WASTEWATER DESIGN SUBMISSION SAMPLE DRAWING.

**WATERMAIN
DESIGN SUBMISSION
SAMPLE DRAWING.**

WASTEWATER DESIGN SUBMISSION SAMPLE DRAWING.

SAMPLE WASTEWATER LONGITUDINAL SECTION SHOWING EXTENT OF SEWER TO BE ABANDONED

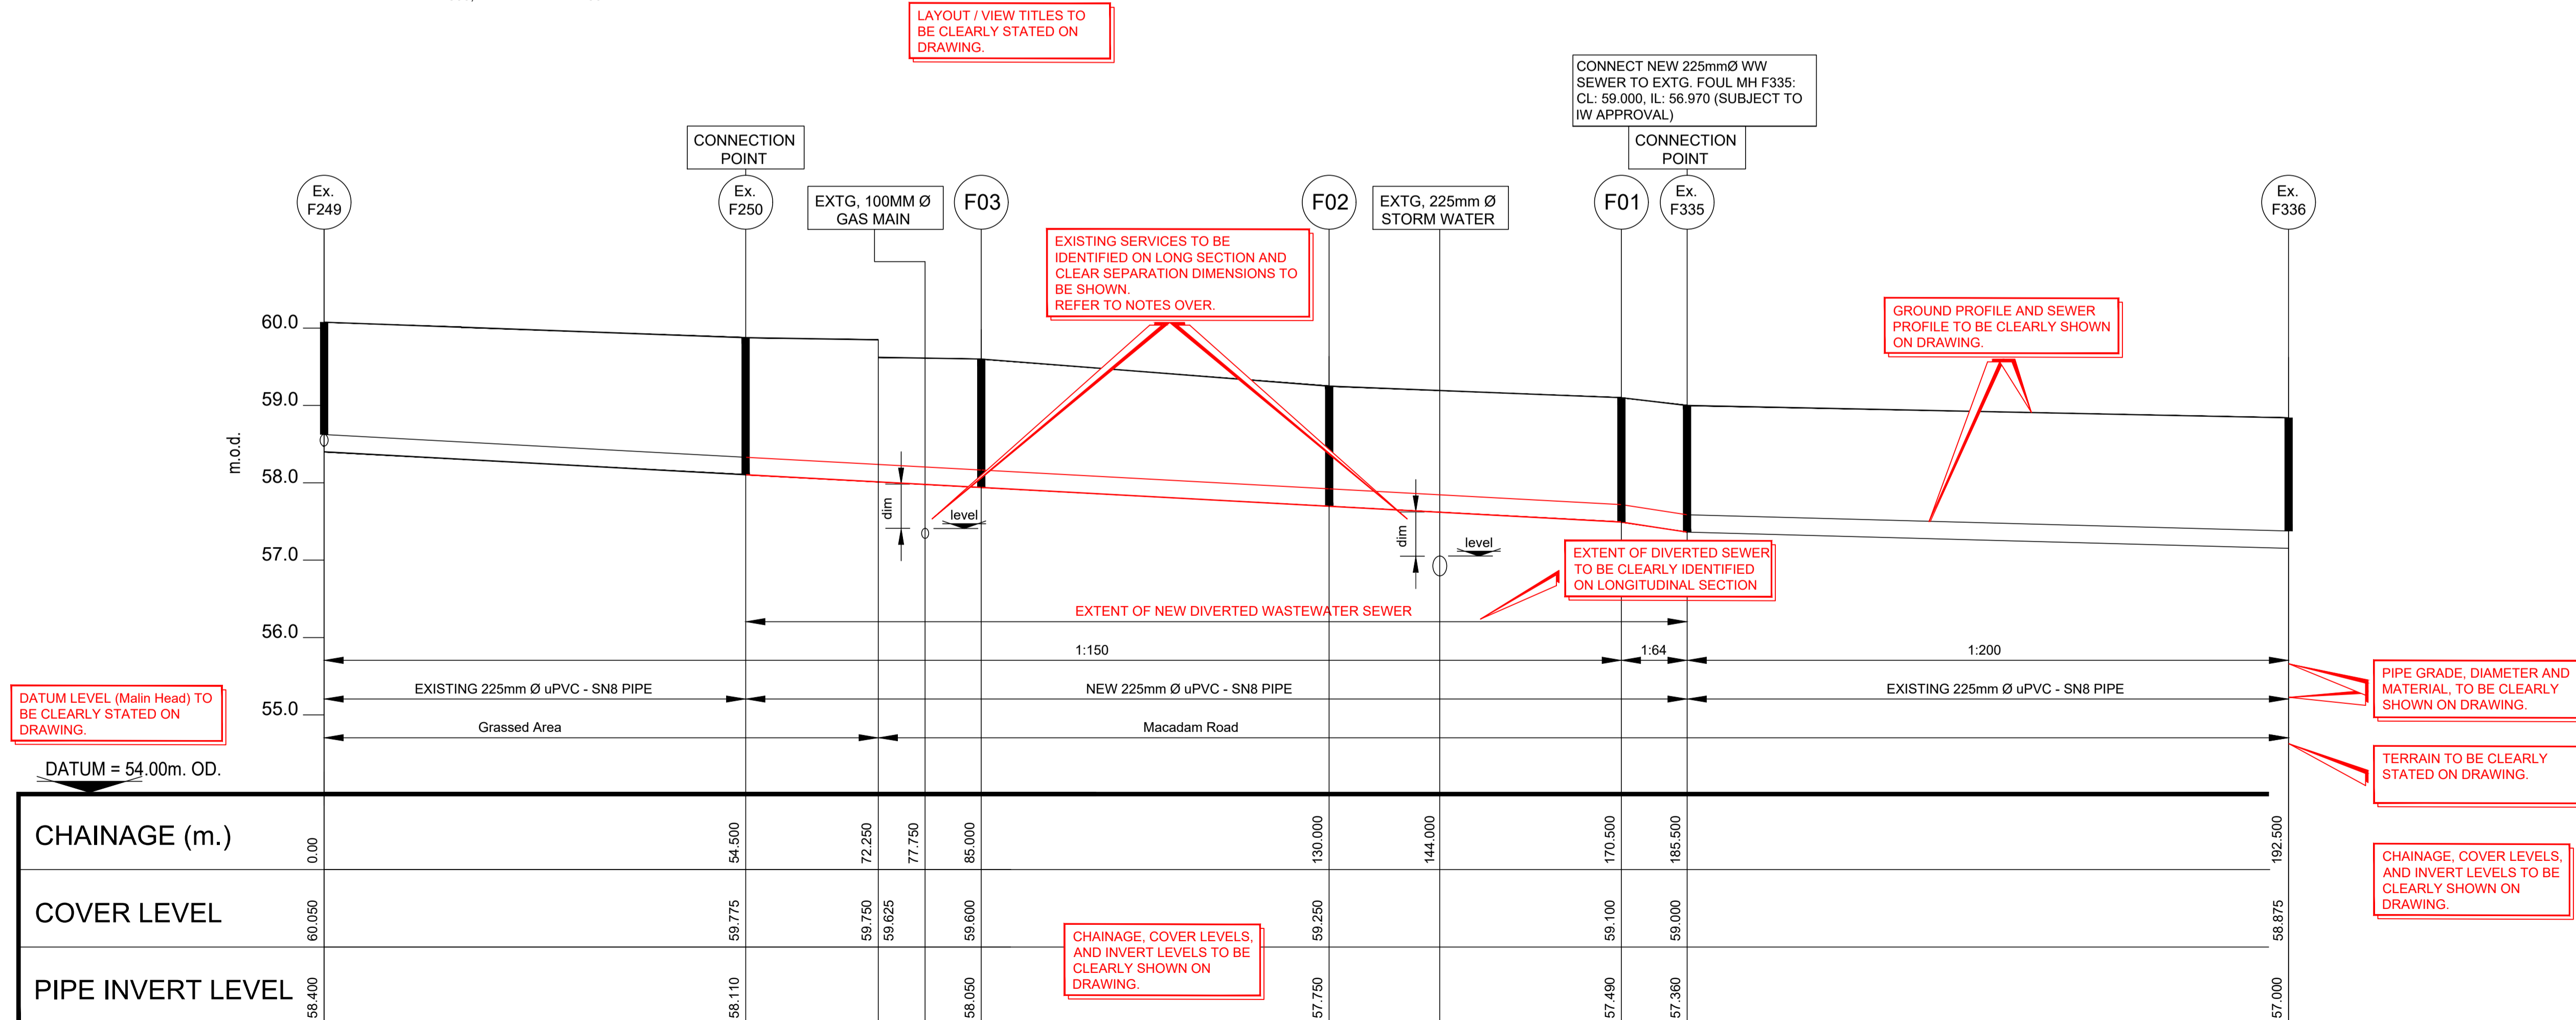
DEVELOPMENT TITLE TO BE CLEARLY STATED.

NAME AND ADDRESS OF DEVELOPER AND CONSULTANT TO BE CLEARLY SHOWN.

DRAWING TITLE TO BE CLEARLY STATED.
